DEPARTMENT OF TRANSPORTATION

February 25, 2013

Re: Dominion Raceway – TIA/Rezoning Submittal
Access Management Exception Request
Route 606, Spotsylvania County

As requested, VDOT has reviewed the above-mentioned TIA & Rezoning submittal, submitted to this office on January 24, 2013. Comments are as follows:

UPC 100829
Route 606 over I-95
CONCEPT C

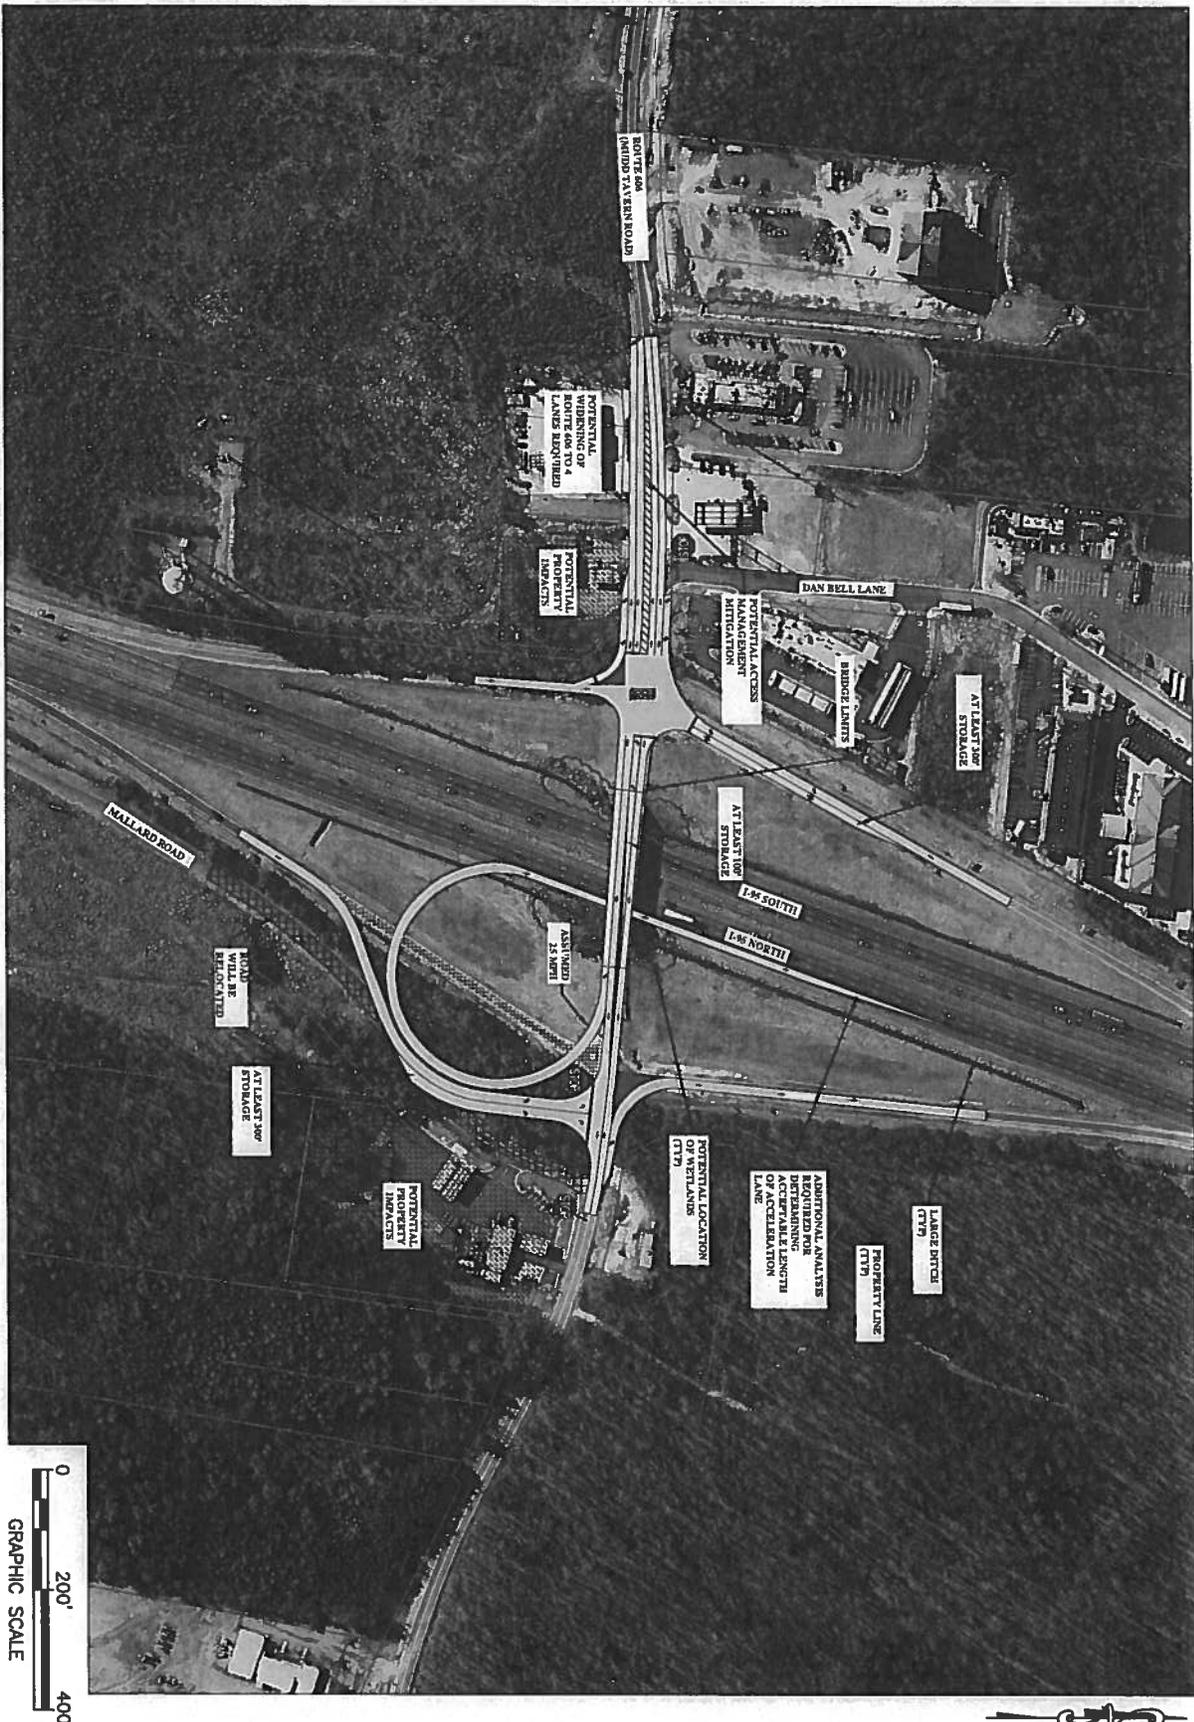
- b. The modified option “C” interchange configuration for the eastbound left to turn into the Dominion entrance is forecast to have a 521 foot queue in the Saturday peak hour, which needs to be addressed. This alternative also calls for a six-lane bridge, however the interchange bridge replacement project is preliminarily planned as a 4 lane bridge, per the attached current Concept C exhibit. Please re-run the analysis based on this 4-lane section, or proffer two (2) additional lanes for the bridge.
